CITY OF MOUNTAIN VIEW

STAFF REPORT

WEDNESDAY, SEPTEMBER 4, 2019

6.1 Request for a 259,034 Square Foot, 6-Story, Office Building and a 7-1/2-Story Parking Garage at 465 Fairchild Drive

Figure 4 – View from the East

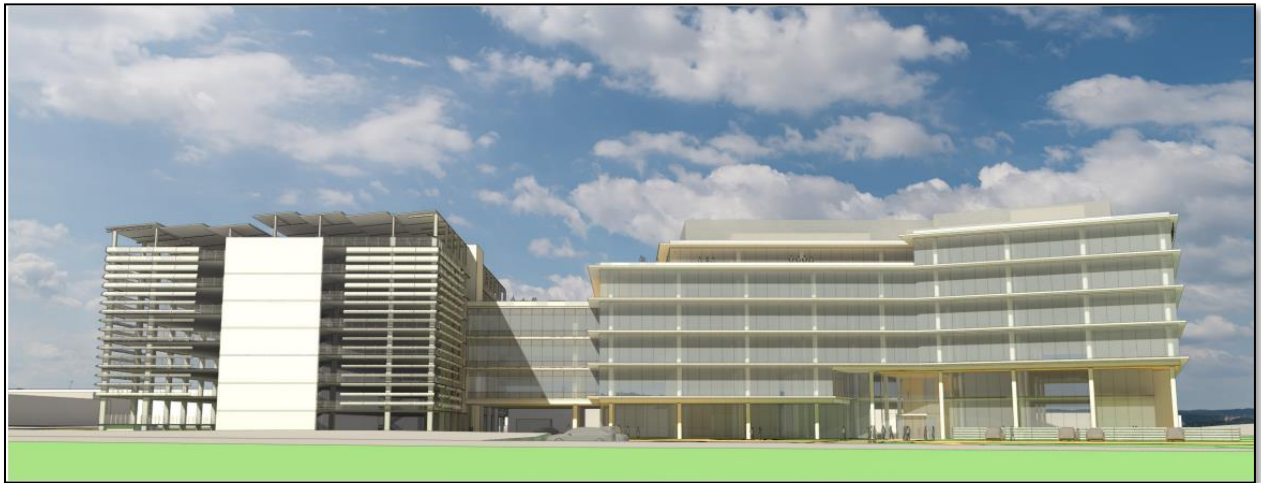
has requested that the overhangs be proportional on all elevations to create the desired horizontality and deep overhang accent on all elevations, including the Fairchild Drive/freeway elevation. The Fairchild Drive overhangs are currently only 3' deep, which makes the front appear stubby and contributing to a less dynamic, interesting building appearance from the freeway and Fairchild Drive especially.

Since the first DRC meeting, the applicant has adjusted the structural design, glazing/material expression, and massing to better frame the entrance through step-backs at the top level and high-volume recesses at ground-level; however, the entrance still needs a stronger pedestrian level experience. While the warm, wood soffit is supported by staff, staff recommends the building entry provide a more distinctive architectural expression (in the lobby and/or building exterior) that is coordinated with more pedestrian-level site and frontage improvements to achieve a more pedestrian-friendly main building entry.

Figure 6 – Common Useable Open Area

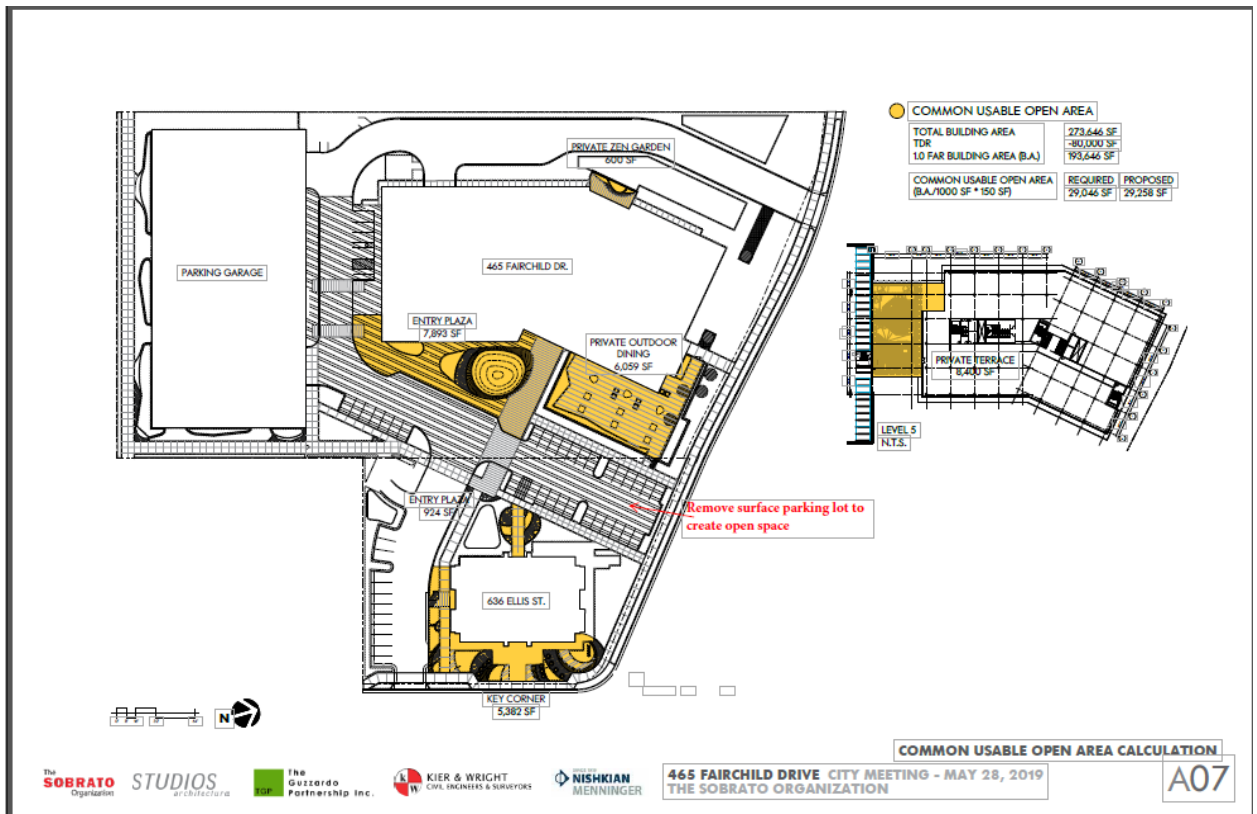
The project plans identify 29,258 square feet of proposed common usable open area, and the applicant has based the required open space area calculations in the plans on the total building area without the 80,000 square feet of TDRs. However, the project also identifies several open areas that do not comply with the EWPP's required open area dimensions and use limitations. Specifically, the key corner and entry plaza is identified as a common usable open area, though most of it is provided pursuant to the public multi-modal requirements. Also, the private terrace would only be accessible to the new building tenants. The project will need to provide open space on the entire building square footage, including TDR square footage, and removing noncompliant open areas would result in the project having common usable open area substantially below the EWPP standard.

Staff recommends removing the surface parking lot on Fairchild Drive to meet the open space requirement and to address EWPP direction to discourage surface parking lots. Programming the Stormwater Protection areas (C3) also have potential to be open space areas which could help the project achieve compliance with the EWPP standards. As noted above, the project is required to provide 38,855 square feet of common, useable open space, and these changes could help achieve a more compliant project.

EPC Question No. 1: Does the EPC support staff recommendations to remove the surface parking lot on Fairchild Drive and program stormwater areas to help achieve compliance with the common, useable open space requirements?
